**SYDNEY CENTRAL CITY PLANNING PANEL**

**COUNCIL ASSESSMENT REPORT**

<b>SCCPP Reference</b>	PPSSCC-98
<b>DA No:</b>	DA/269/2020
<b>Property:</b>	Lot 1 DP 952720, Lot 1 DP 972068 & Lot 10 DP 605684, No. 24-26 Railway Parade, WESTMEAD NSW 2145
<b>Proposed Development</b>	Demolition, tree removal and construction of a part 4, part 14-storey mixed use development over 4 levels of basement. The mixed-use development will comprise commercial uses, a tavern, a medical centre and a hotel. The proposal also includes changes to the VPA relating to public domain upgrades, site preparation works, public domain works and an accessible through site link. The proposal is Integrated Development pursuant to the Water Management Act 2000. The application will be determined by the Sydney Central City Planning Panel.
<b>Date of receipt:</b>	11 May 2020
<b>Applicant:</b>	Drill Pty Ltd
<b>Owner:</b>	Drill Pty Ltd
<b>Property owned by a Council employee or Councillor:</b>	The site is not known to be owned by a Council employee or Councillor

**Figure 6: Proposed changes to the escalator to be relocated to the rear along the stairs.**

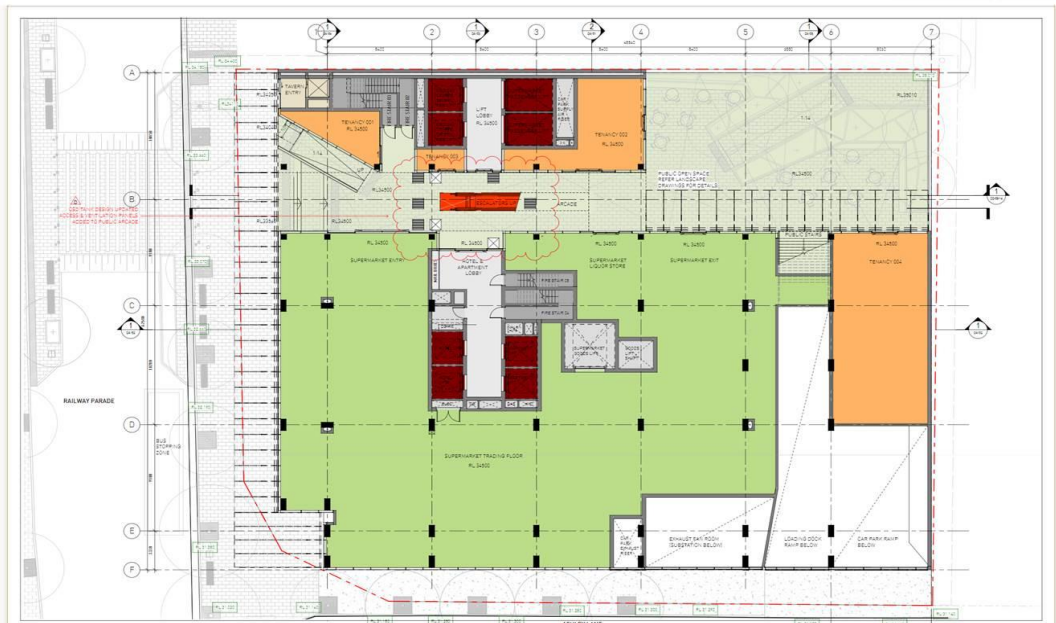
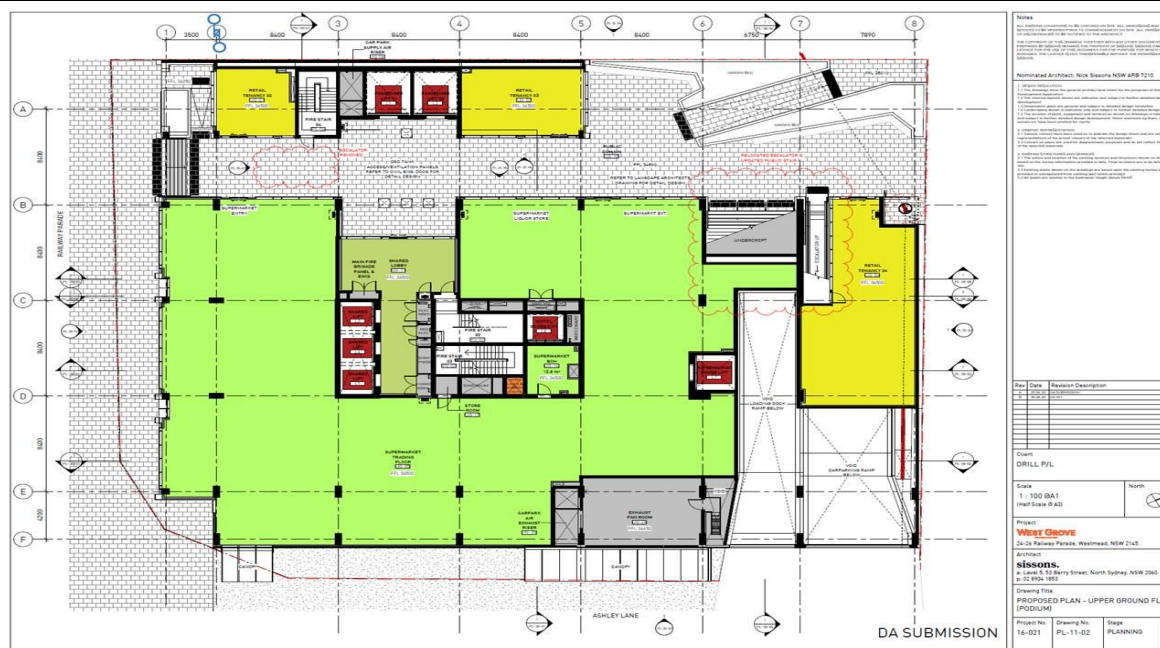
- *The proposal includes a through-site link which would facilitate pedestrian connection to Hawkesbury Road and the medical facilities in this location. The assessment should clarify whether pedestrian flow has been adequately considered noting the busy location of the site, which also sits between the heavy rail and light rail stations. The assessment should clarify that potential pedestrian pinch points or bottle necks have been addressed.*

The Panel recommended reconfiguration of the escalator as its current location compromises the scope for fluid pedestrian movement with a projected high volume of people expected to use this link. Alternative locations for the escalator were discussed, but it was decided a preferable outcome would be to have access from street level on Railway Parade directly rather than first having to take stairs or the ramp.	<p>Despite the escalator being supported and approved in the through-site link under DA/381/2018, the architect has considered a series of options for the relocation of the escalator in consultation with food and beverage experts.</p> <p>As a result, the escalator is proposed to be relocated to the rear of the site alongside the entry stair to the level 1 food and beverage precinct/ tavern. The new location is considered to adequately address the panel's concerns about compromising fluid pedestrian movement.</p> <p>The architects explored locating the escalator along Railway Parade as suggested by the Panel, but this was considered to impact upon ground plane activation and required extensive changes to the proposed retail layout and design.</p>	Council's Urban Design team have reviewed the amended location of the escalator to the rear of the site alongside the entry stair to the level 1 and considers that the relocation of the escalator to adequately address the panel's concerns about compromising fluid pedestrian movement.

The changes to the approved through site link are designed to provide improvements for pedestrian movement through the site and avoid potential pinch points and bottle necks. These changes are, as follows:

- Rationalisation of the entry of the through site link from Railway Parade through a consistent width;
- Relocation of the escalator from the centre of the through site link, to the rear of the site, removes potential pinch points; and
- Widening of the area in front of the lifts to create more waiting space for people off the main path of pedestrian movement reduces potential pinch points.

The design of the proposed through site link is considered to achieve the right balance of activation with retail uses fronting the space, whilst maintaining adequate width for pedestrian movement through the site to formalise what has always been conceived as a secondary pedestrian link. This is on the principal that Railway Parade will remain the primary pedestrian access between the Westmead Train Station and Hawksbury Road where access to the light rail station is located, and beyond to Western Sydney University and the hospitals.
